Appl. No. 10/749,610 Amdt. dated Mar. 7, 2005 Reply to Office action of 12/07/2004

Amendments to the Drawings:

Fig2B added

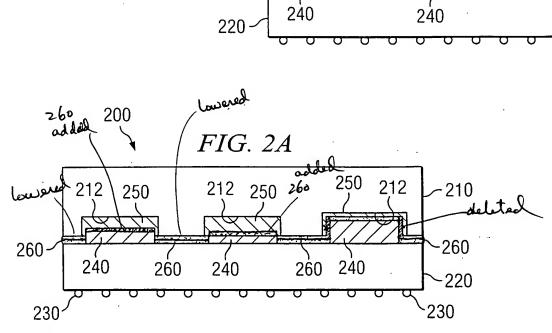
The attached sheet of drawings includes changes to Fig. 2A and the new drawing, Fig. 2B, replaces the original sheet including Fig. 1, 2, and 2A. In Figure 2A, o the missing elements 260 on top of the dies are added, and the thickness of elements 260 that contact the substrate 220 is reduced with respect to the chip thickness to depict the embodiment more closely. No new matter is added.

- 1. Applicant amends the specification to correct a typographical error. There is no new matter in the amended specification.
- 2. Applicant amends drawing figure FIG. 2A to depict the invention more clearly. There is no new matter in the amended drawings.
- 3. Applicant adds new drawing figure 2B following the instruction in ¶3 of the Office action to show two dies operable to fit inside one cavity when the lid is coupled to the substrate as described in the original claim 22. There is no new matter in the new drawing.
- 4. Applicant cancels claims 1-14, 23, 24, and 35.
- 5. Applicant amends claim 32 according to the instruction in ¶4 of the Office action to overcome the objection.
